Errata for the
PCI Express[®] Base Specification
Revision 2.1

November 18, 2010

Errata for the PCI Express Base Specification, Revision 2.1

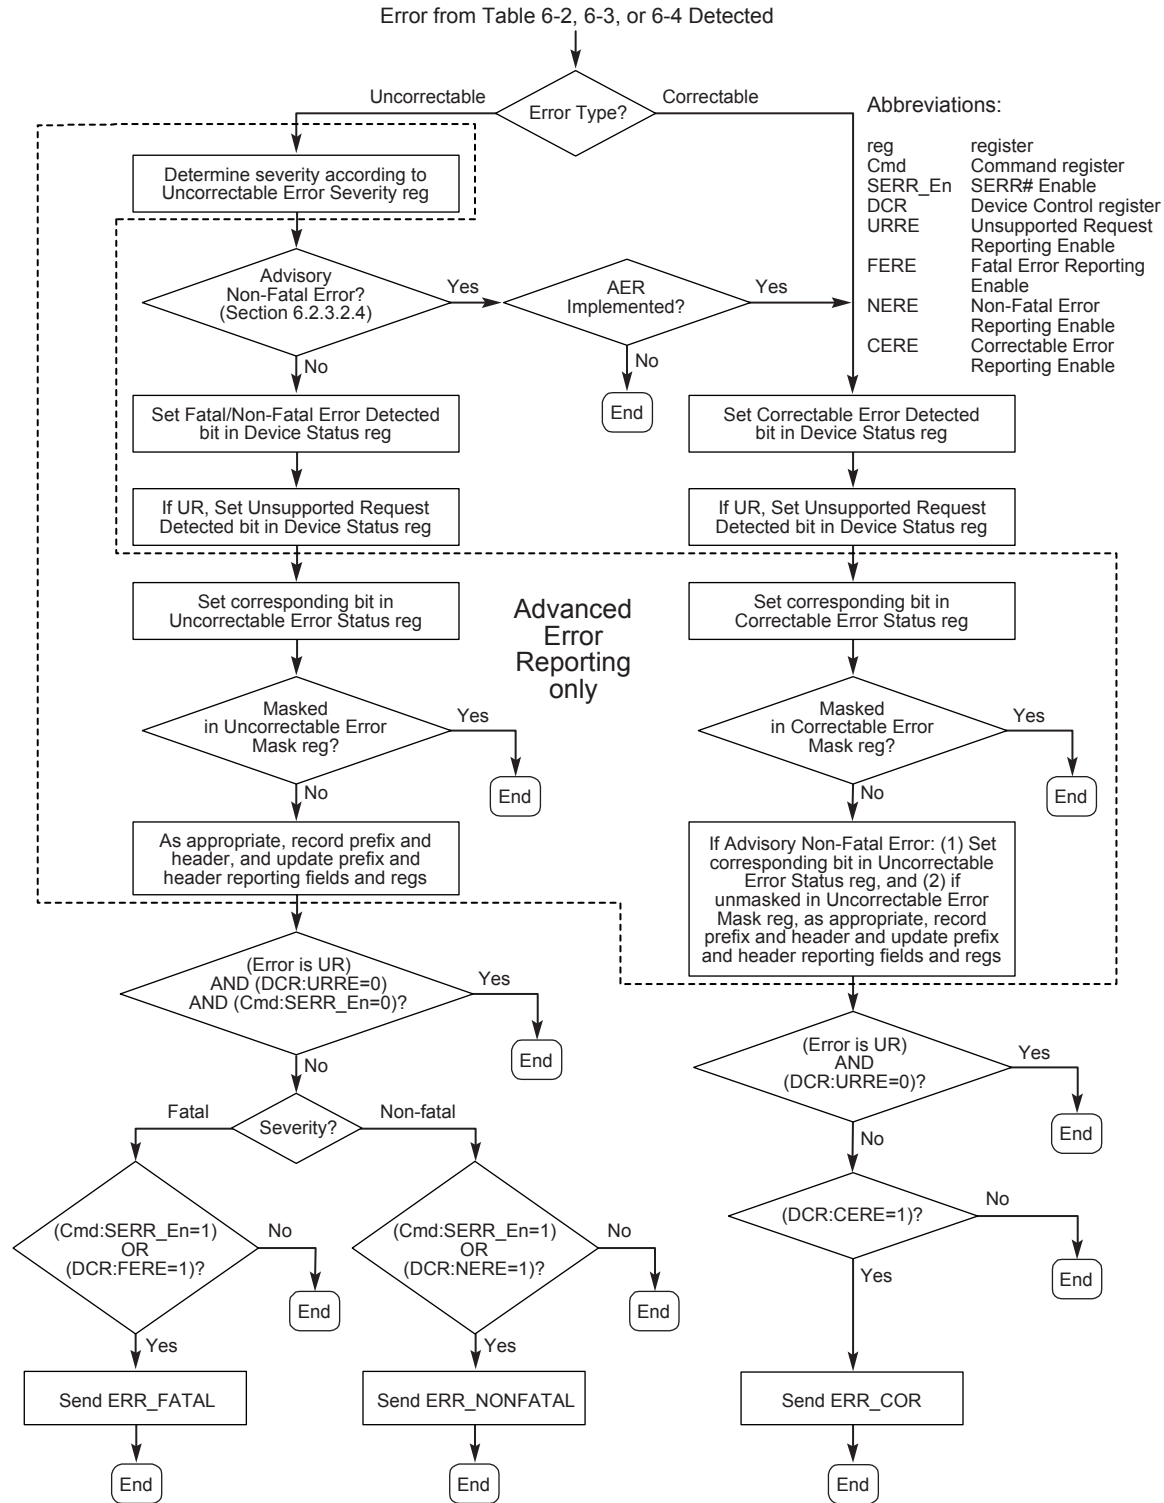
A 32-bit ECRC is calculated for the ~~entire~~ TLP (End-End TLP Prefixes, header, and data payload) using the following algorithm and appended to the end of the TLP (see Figure 2-3):

- The ECRC value is calculated using the following algorithm (see Figure 2-37).
- The polynomial used has coefficients expressed as 04C1 1DB7h
- The seed value (initial value for ECRC storage registers) is FFFF FFFFh
- All invariant fields of the TLP's End-End TLP Prefixes (if present), header, and the entire data payload (if present) are included in the ECRC calculation, all bits in variant fields must be set to 1b for ECRC calculations.

OM14544C

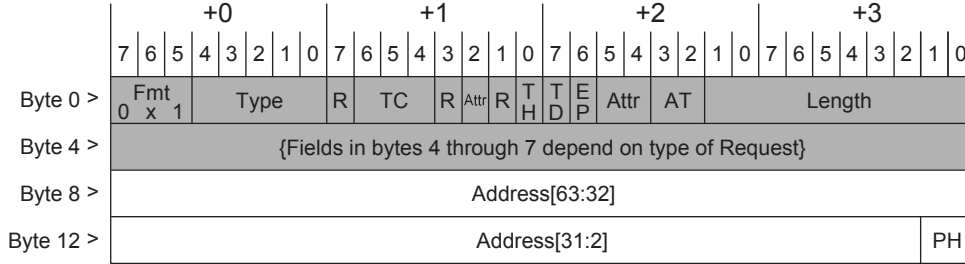
In Section 2.2.4.1, page 64, replace Figure 2-7: 64-bit Address Routing with the following:

OM14543C

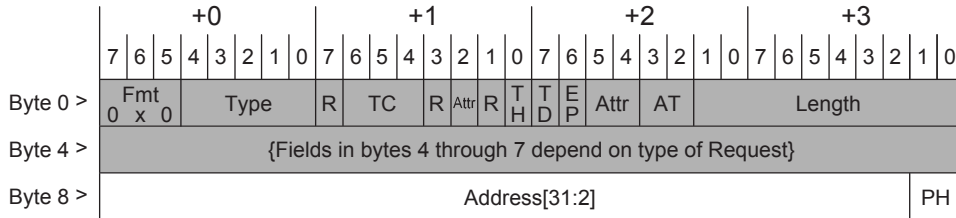
In Section 2.2.4.1, page 64, replace Figure 2-8: 32-bit Address Routing with the following:

OM13764C

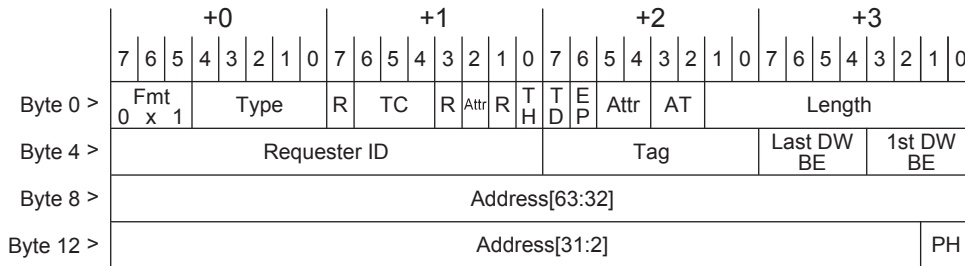
In Section 2.2.7, page 77, replace Figure 2-15: Request Header Format for 64-bit Addressing of Memory with the following:

OM13763C

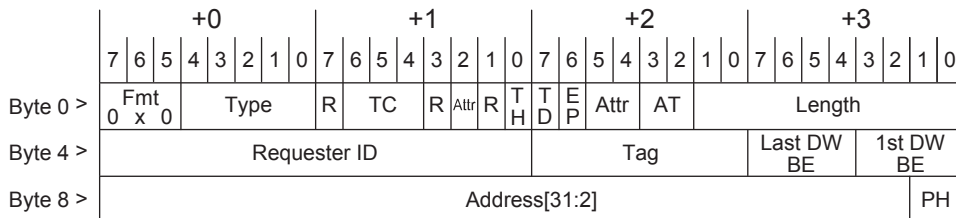
In Section 2.2.7, page 77, replace Figure 2-16: Request Header Format for 32-bit Addressing of Memory with the following:

Figure 4 22: Transmitter Margining Voltage Levels and Codes

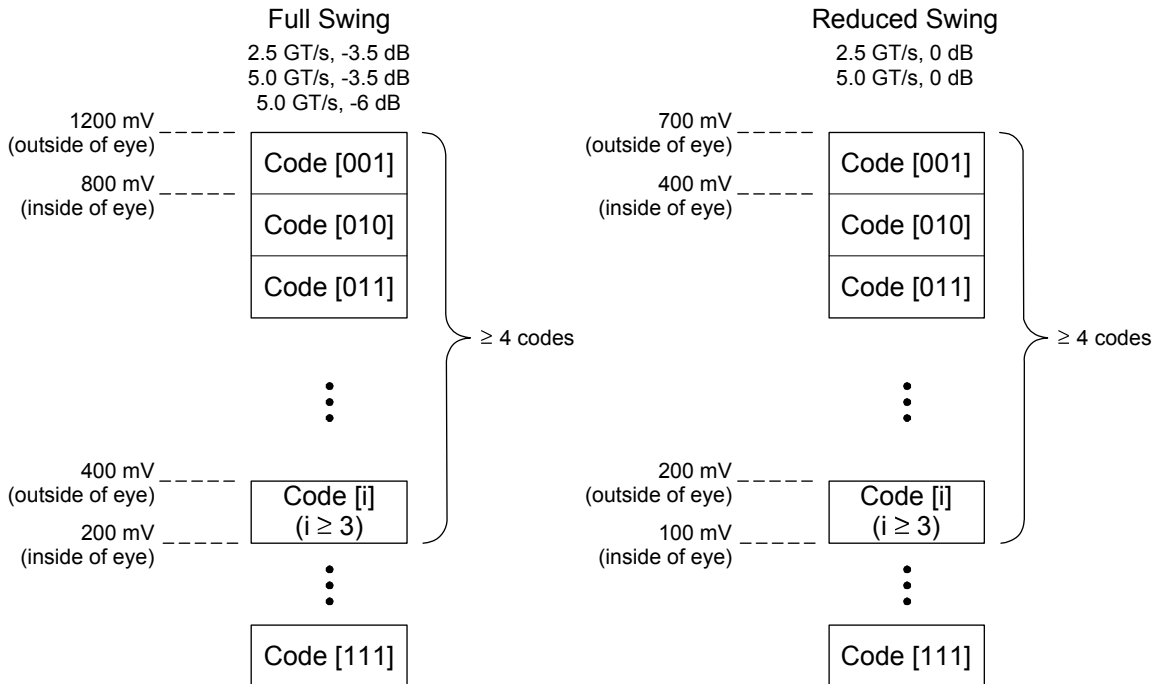
In Section 4.3.3.3, page 267, replace Figure 4-22 with the following:

Figure C-1: Scrambling Spectrum at 2.5 GT/s for Data Value of 0

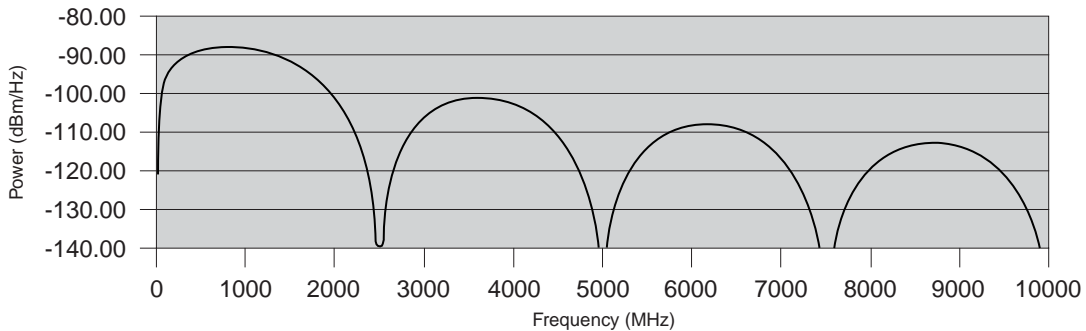
In Section C1, page 685, make the following edits on line 1:

At 2.5 GT/s, scrambling produces the power spectrum (in the 10-bit domain) shown in Figure C-1.
